BDEC Presentation to the Fingerboards Mineral Sands Mine EES 16th July 2021.

Submitter 429 supported by Tabled Documents 203, 248 & 523

Figure 3: Schematic rehabilitation cross section of the mine void from Page 9.1 of Document 215 - Updated Draft Mine Rehabilitation Plan

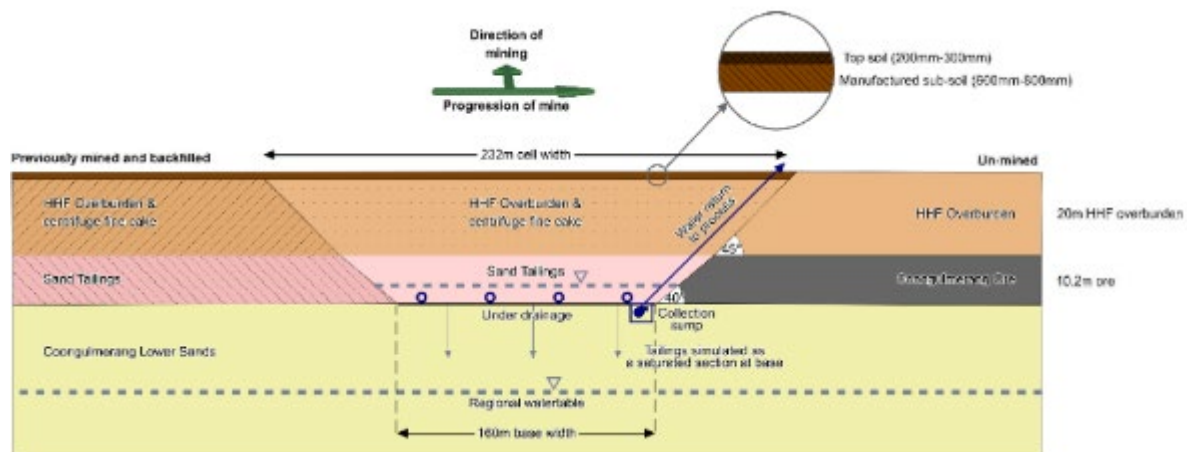
1.9. Is the proponents claim of the JORC assessment of the ore body accurate? Kalbar's own geologist – a major shareholder - was a contributor to this JORC assessment. But Kalbar have failed to describe that zirconium will not be mined from the blocks between or within mine pits, and that the slimes are too fine to process so the zircon they hold will be lost. What is the actual thickness of the Marker layer ? The latest test bores did not intercept slimes in all drill holes – an indication that the orebody may be discontinuous.

Figure 5: Figure 3.4 Draft Work Plan

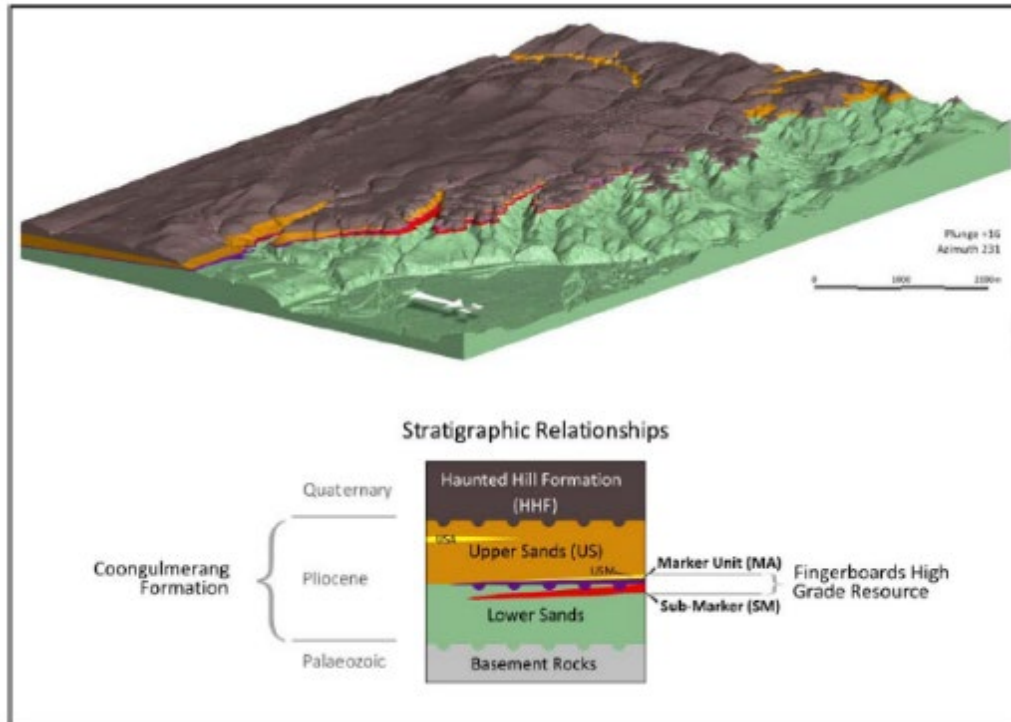
2.1. The fragile geology of the Fingerboards site. The Haunted Hills formation. Map of Fingerboards project area with Haunted Hills formation as an overlay.

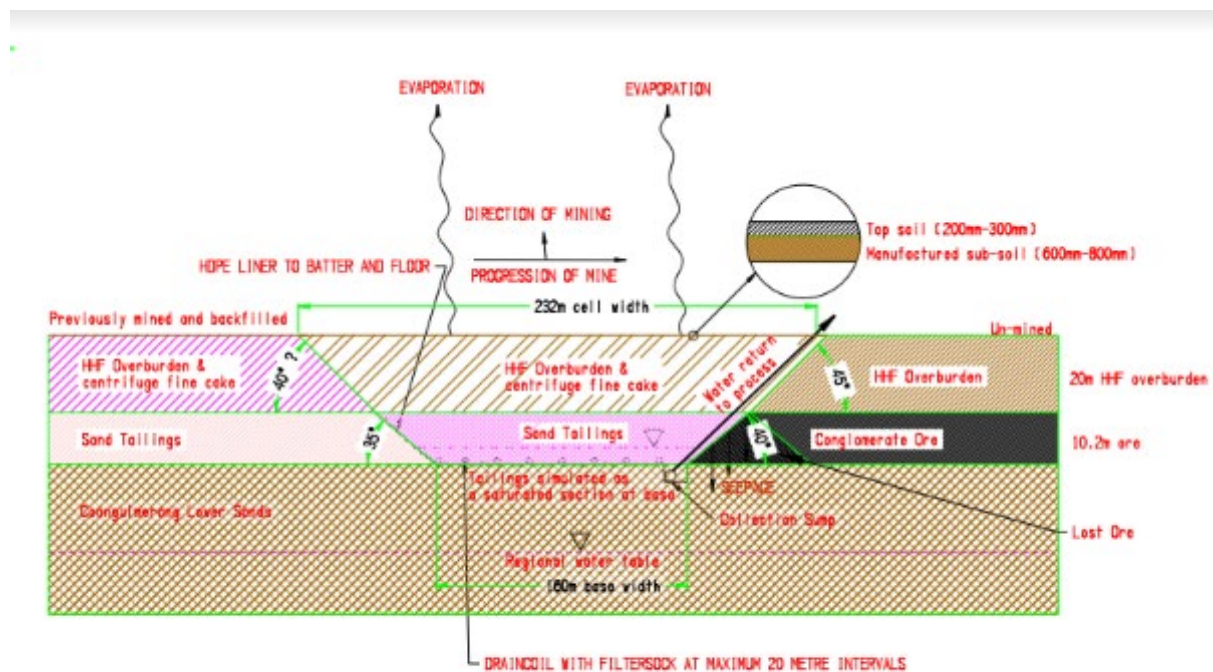
3.3 A sketch of the mine pit adapted from Appendix C. Page 119. Schematic 9-3. This describes the mine pit with inclusion of HDPE membrane, drain pipes and geotextile socks. Recharge of aquifers will not occur with this model. Mine voids will not dry for timely placement of overburden.

EVIDENCE – Sketch of mine pit

Figure 18: Possible flow paths for 'freshwater' dam failure

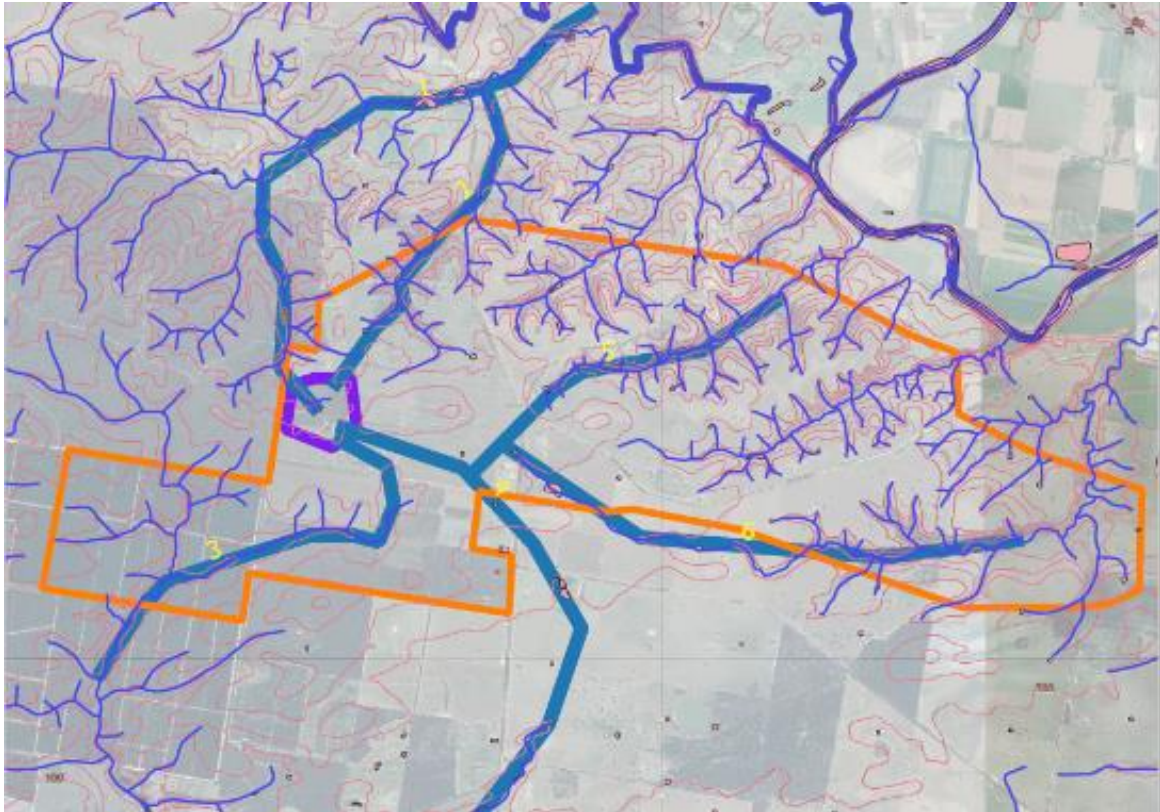
Map of homes on Mitchell River flats at risk from discharge plume. However it is not just 'homes' that are at risk. Significant numbers of people work in the vegetable fields 365 days a year. There are also the issues of flood waters higher than 2m crossing the Dargo Road.

Figure 17: Dam failure has only been modelled for reaching the Mitchell via Moulin Creek. There are other possible paths too that must be considered.

Figure 2 January tabled plans – proposed road network - diversions and staging (Tabled Document 45) ²³

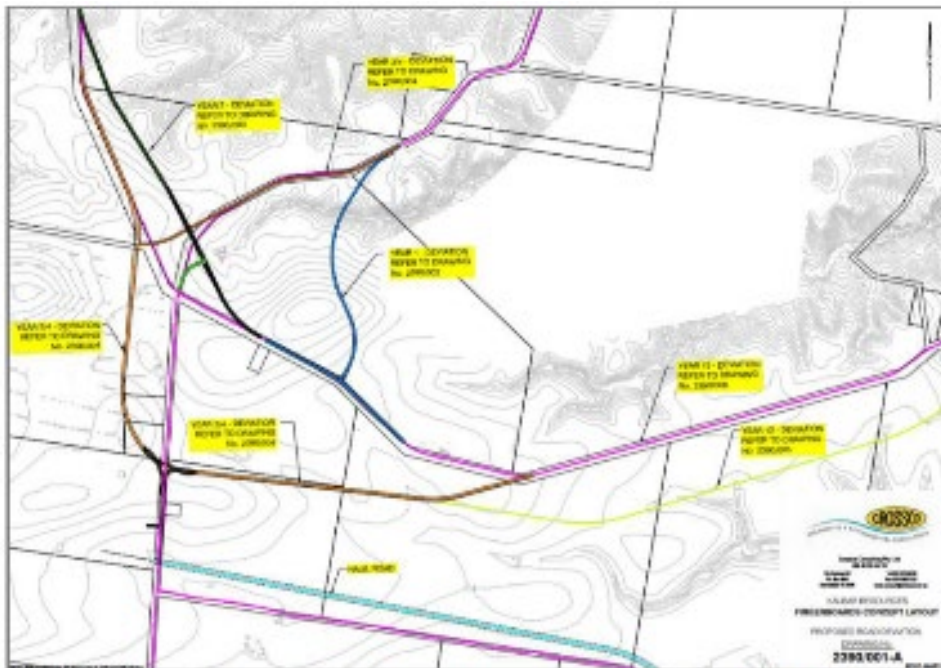
The realigned diverted Fernbank-Glenaladale Road is now being shown going through the Perry Gully.
